Proposed Flood Compensation Area

Submitted: Proposed Site Plan

Amended: Proposed Site Plan

Drawing: H0123-FA-02A-Site Layout Rev A

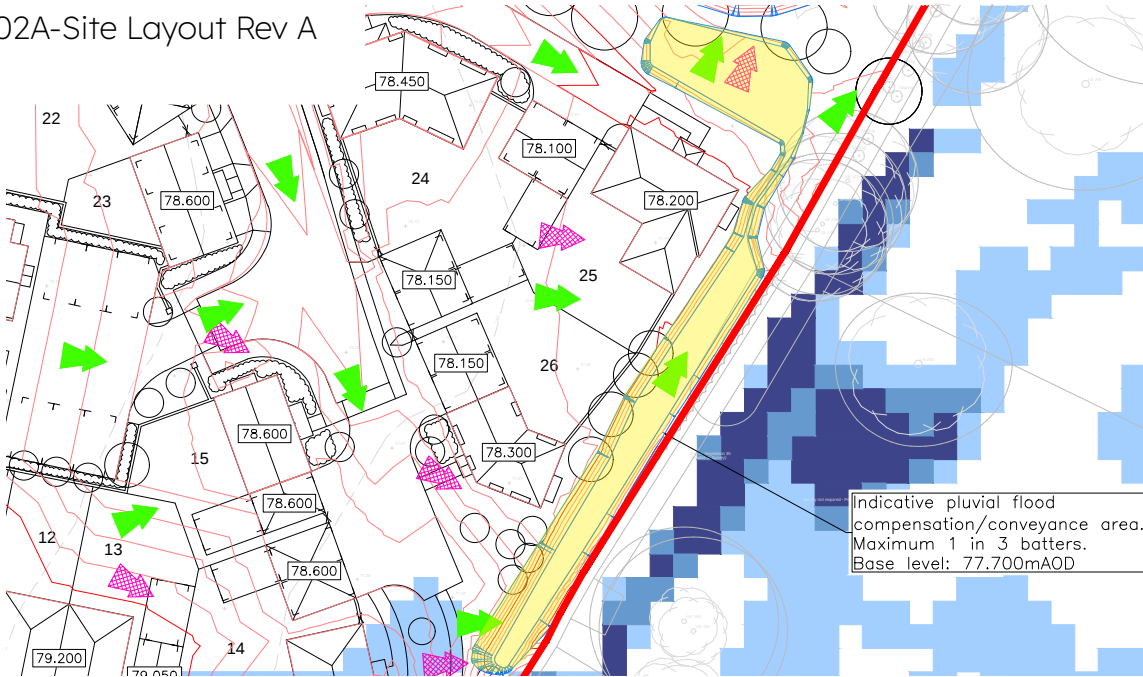
Proposed flood compensation area (approximately 300 mm deep) for temporary surface water storage.

A flood compensation area is proposed in the southeastern corner of the site to further mitigate surface water flood risk. This update has been made in response to changes in the surface water flood risk mapping since the application was submitted. The flood compensation area will prevent surface water from ponding/pluvial flooding as a result of overland flows. Notwithstanding the above, the risk of surface water flooding in this area is considered to be low.

Drawing: H0123-FA-13A-Levels Plan Rev A

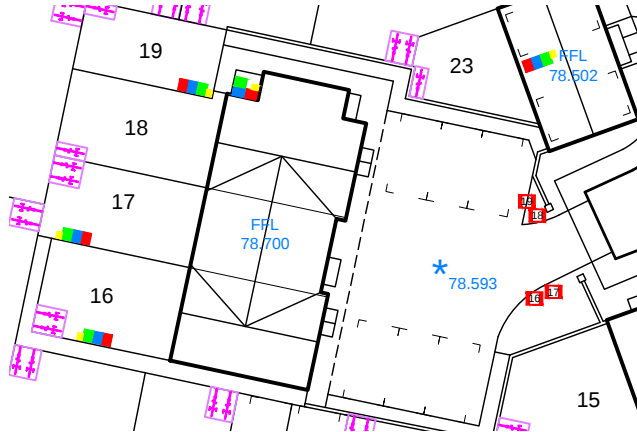
Site levels have been revised in line with the updated drainage strategy to ensure that overland flow routes through the site are maintained. The revisions also regularise site levels and remove localised low points, particularly around Plot 14, where surface water could otherwise accumulate. Proposed finished floor and ground levels have been raised above existing ground levels across the site to fully mitigate the risk of on-site surface water flooding.

The proposed level changes are highlighted in red on the amended Levels Plan.

Drawing: H0123-FA-02A-Site Layout Rev A

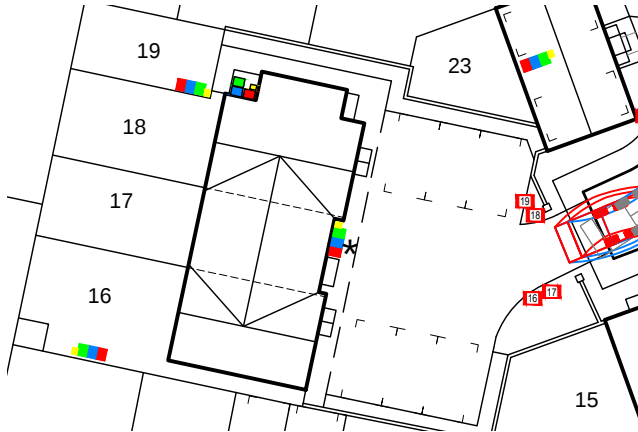
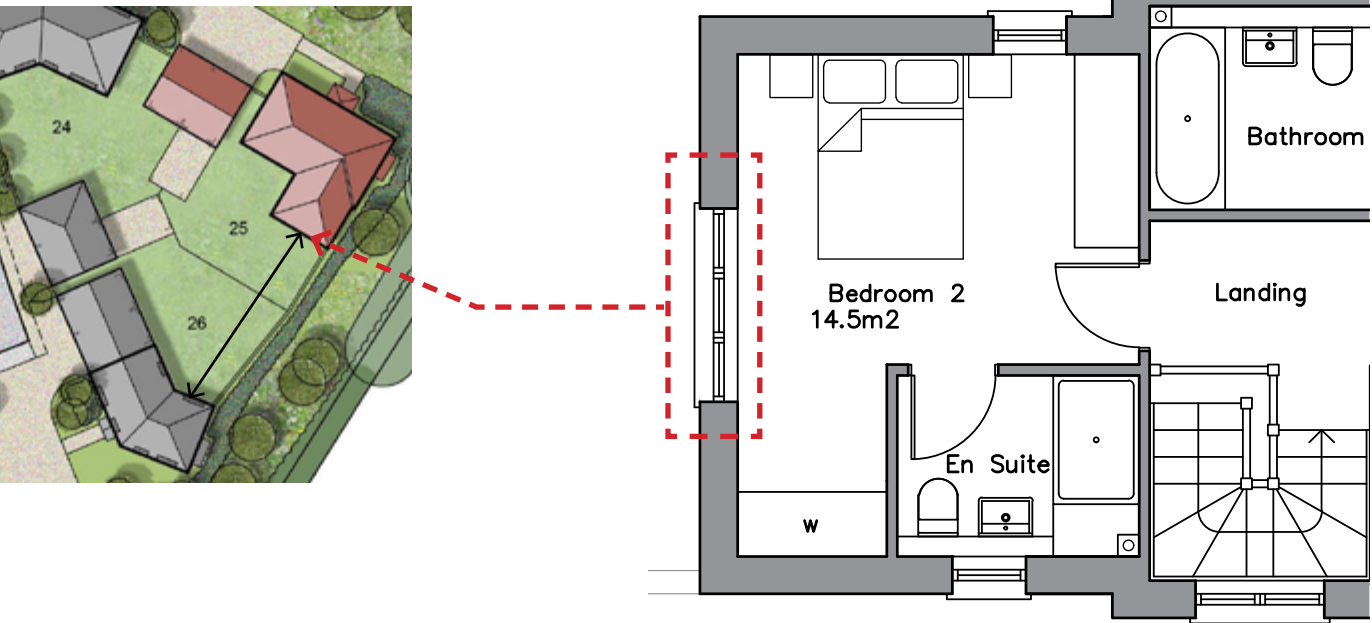
The garden serving Plot 16 has been enlarged through the removal of the shared rear access path to Plot 17. This amendment ensures that the private amenity space provided for Plot 16 exceeds the minimum policy requirements for a dwelling of this size.

A bin store will now be provided to Plot 17 to ensure bins are appropriately concealed from view.

Drawings:
H0123-FA-230A- Floor Plans Plot 25 Rev A
H0123-FA-231A- Elevations Plot 25 Rev A

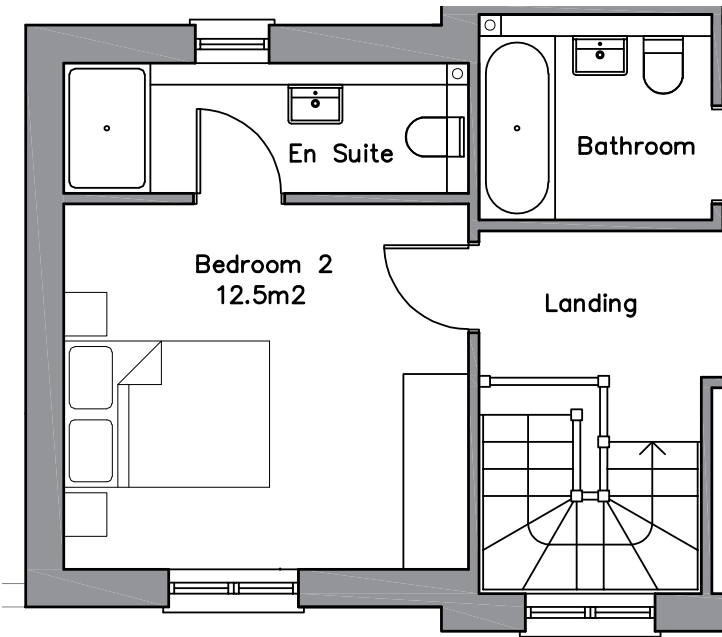
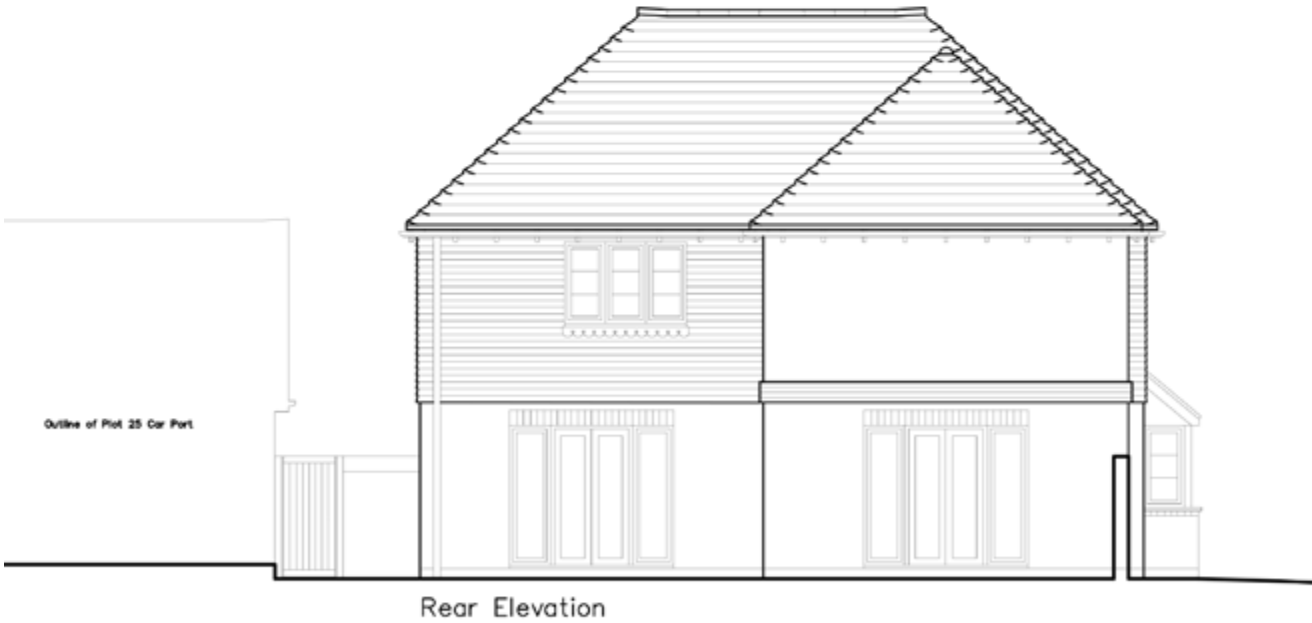
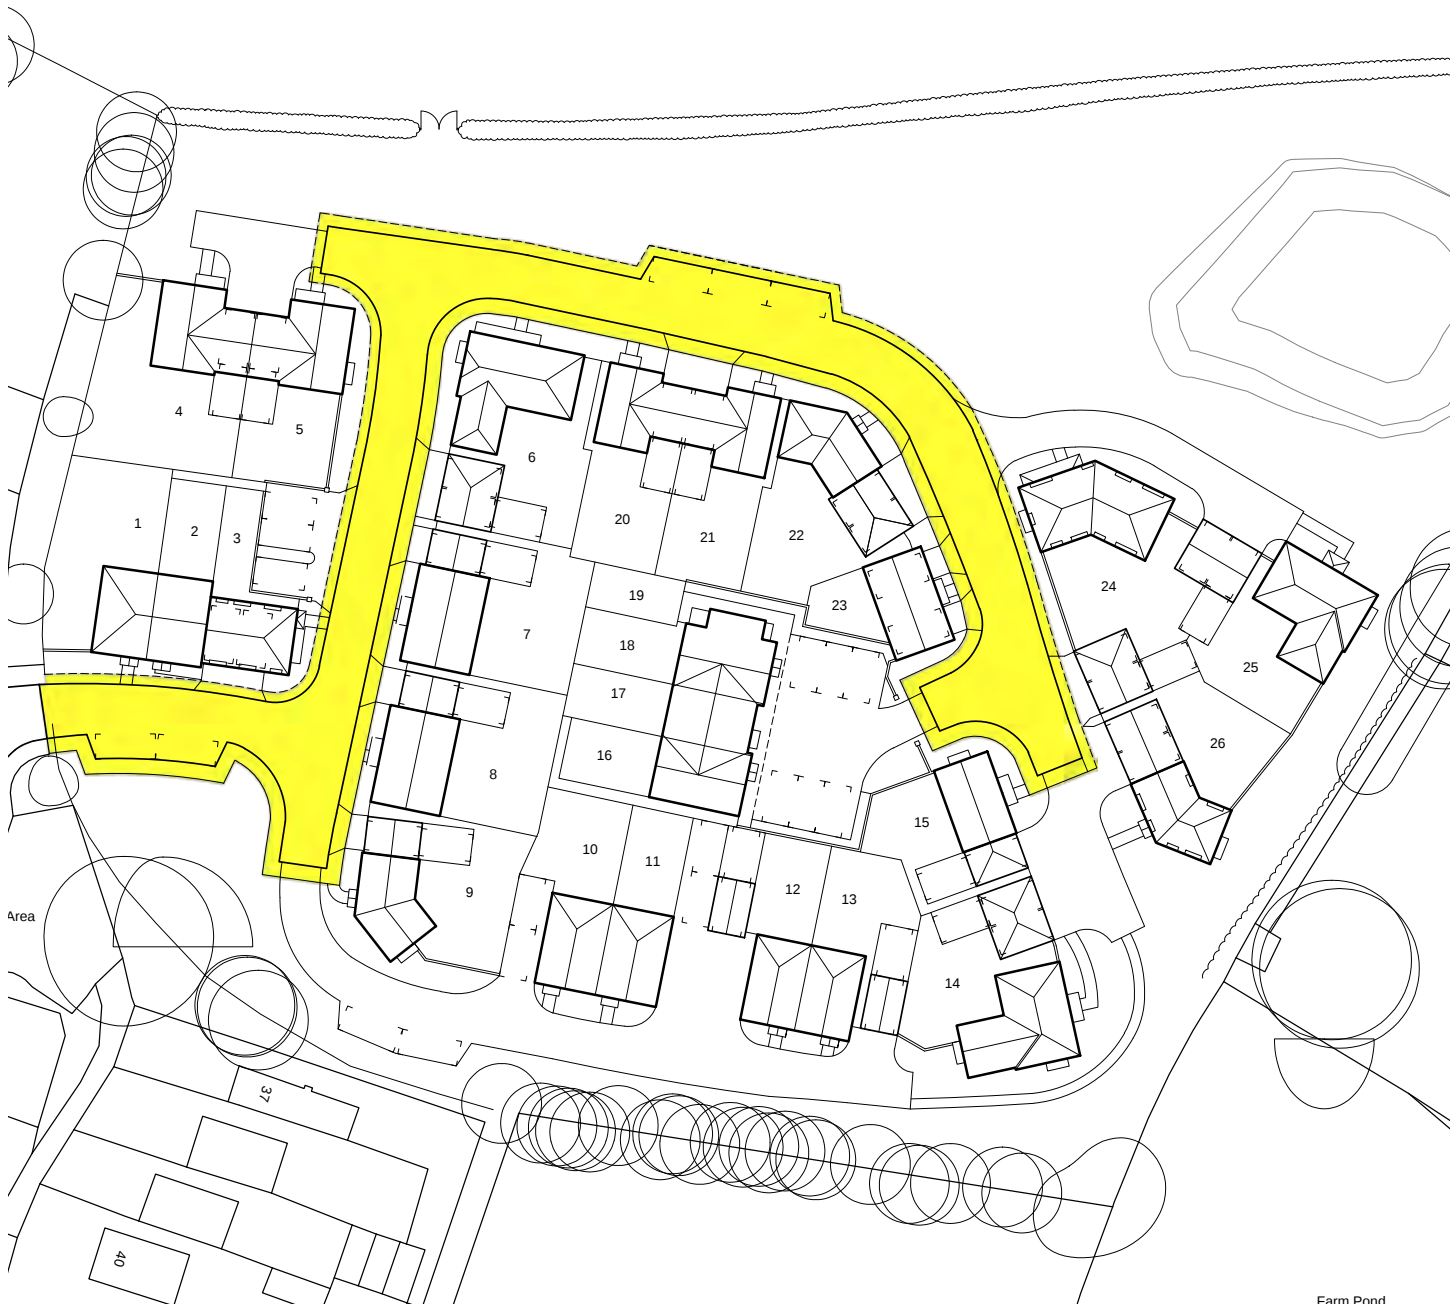
The proposed first-floor layout of Plot 25 has been amended through the removal and repositioning of a window within Bedroom 2. This revision addresses the overlooking relationship with Plot 26 and improves privacy between the two properties.

Drawing: H0123-FA-11B-Adoptable Highway Plan Rev B

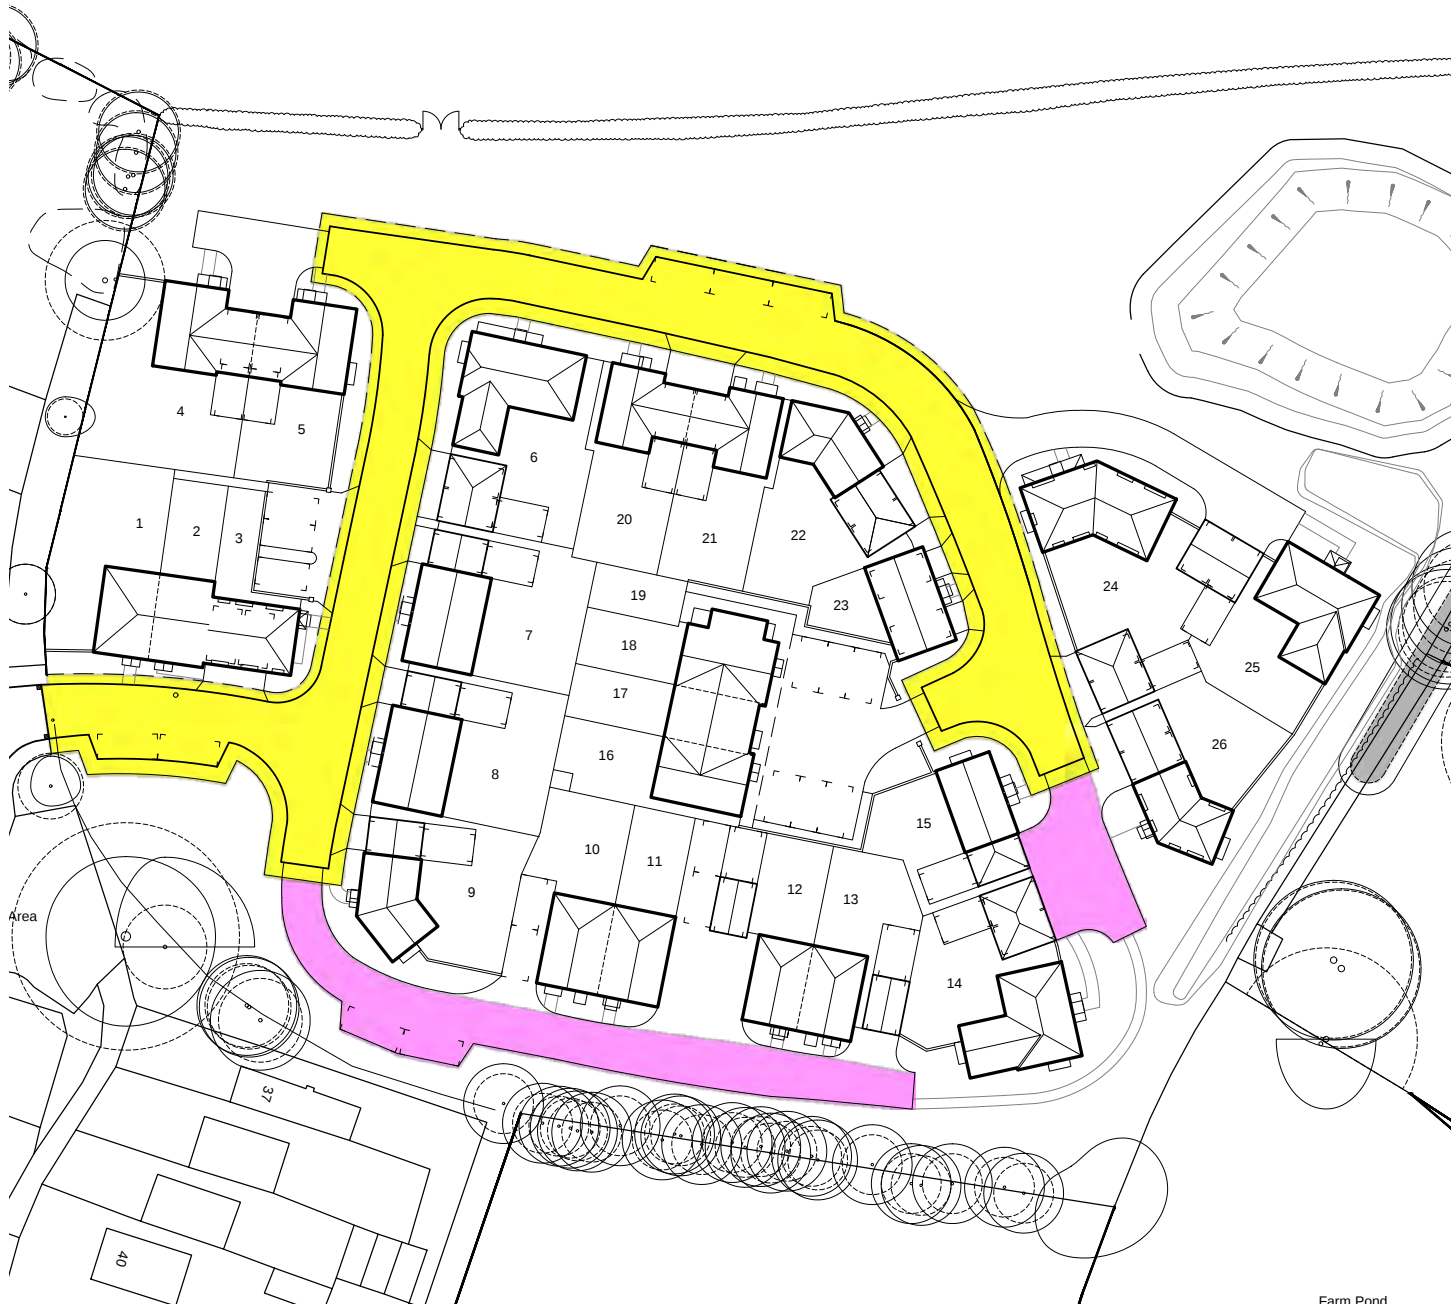
The above plan has been amended to demonstrate that the construction of the unadopted shared surface roads is suitable for use by fire appliances and refuse vehicles, ensuring access to all dwellings within the site.
